DCN No. E020964-00-W

ENGINEERING CHANGE NOTICE (ECN)

DOCUMENT No. (DOC-REV-GP. ID)	TITLE	NEW REV.
LIGO-D960395-02-W		03

END
STATION
"B" LIGO-D960395-02
WA-E-106 Rev 2

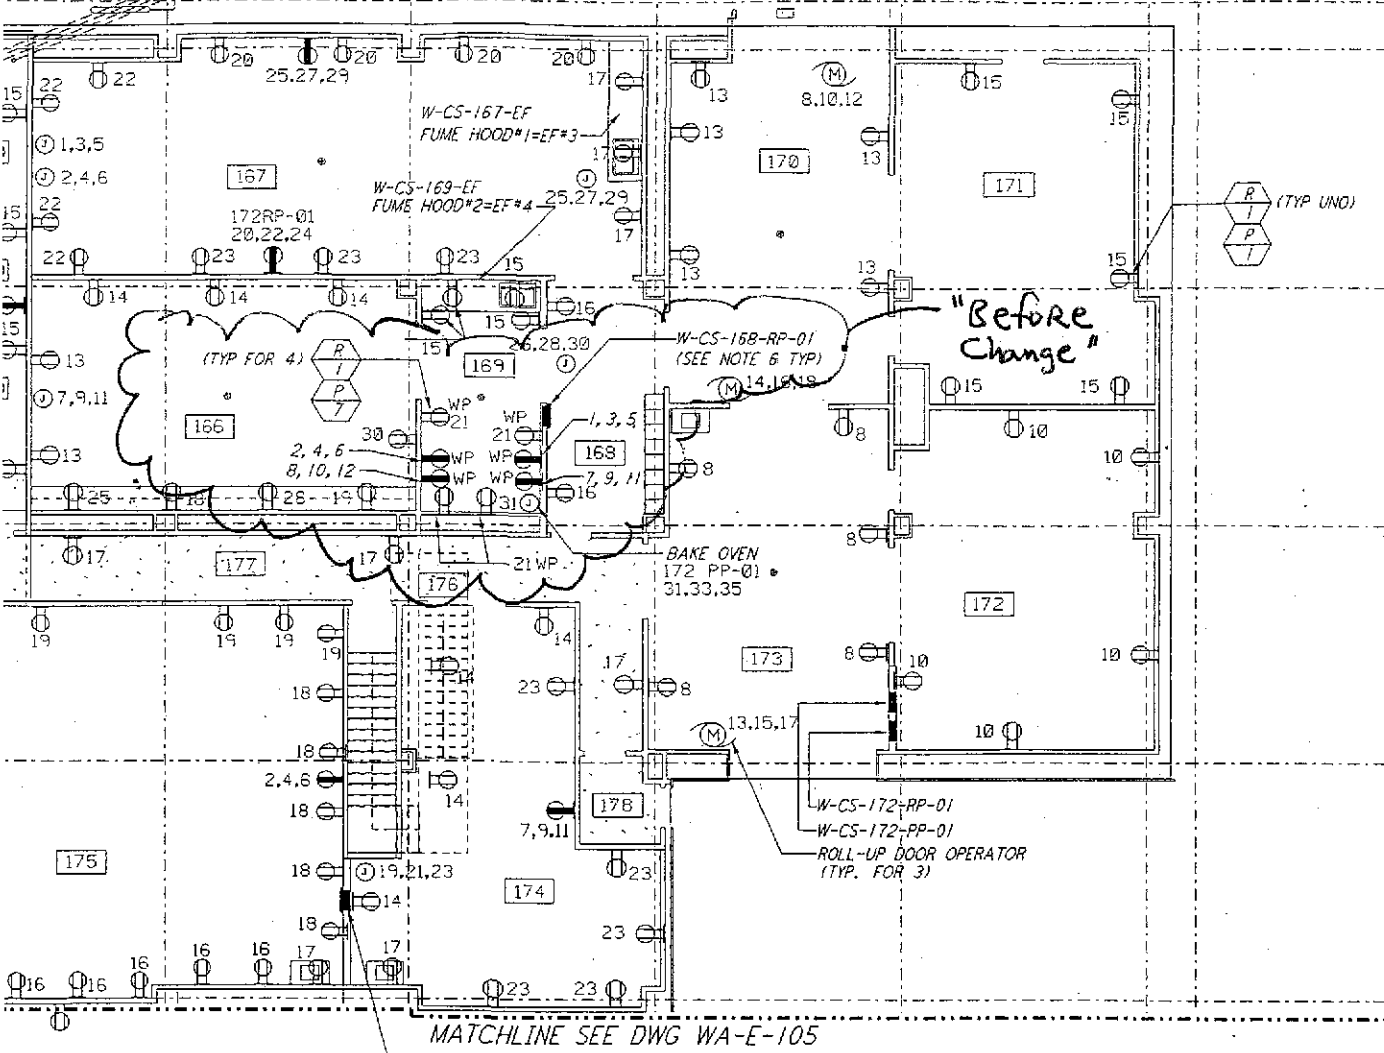
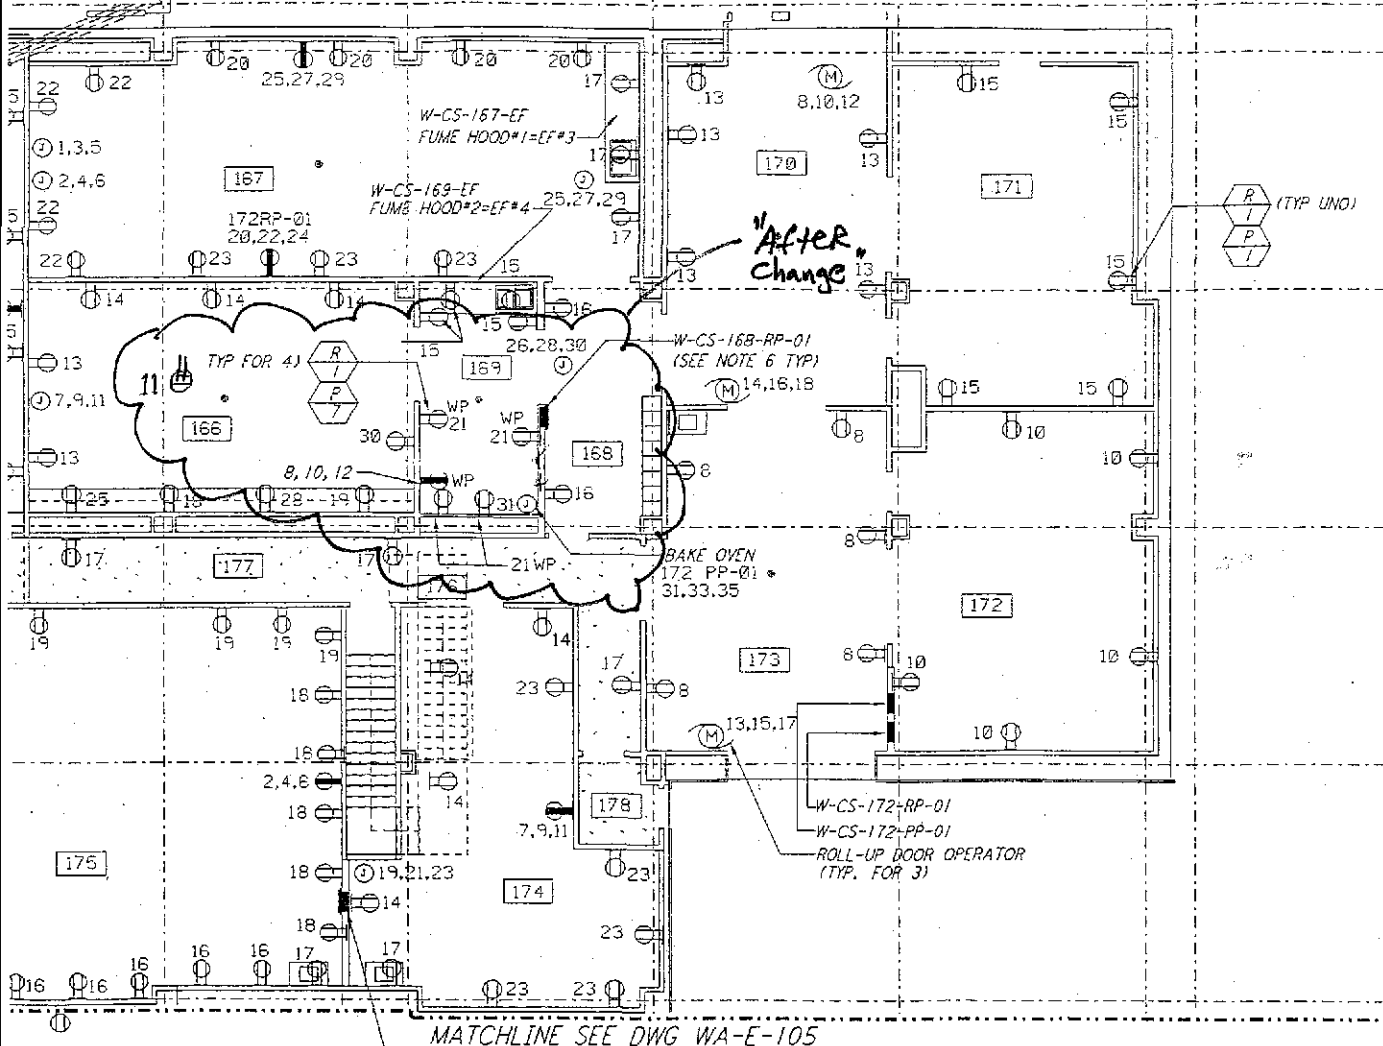
Removed two receptacles from North wall and one receptacle from South wall of Room 169
 Added dual duplex receptacle at center (overhead) of room 166

REASON FOR CHANGE: To make drawing consistent with "As is" configuration
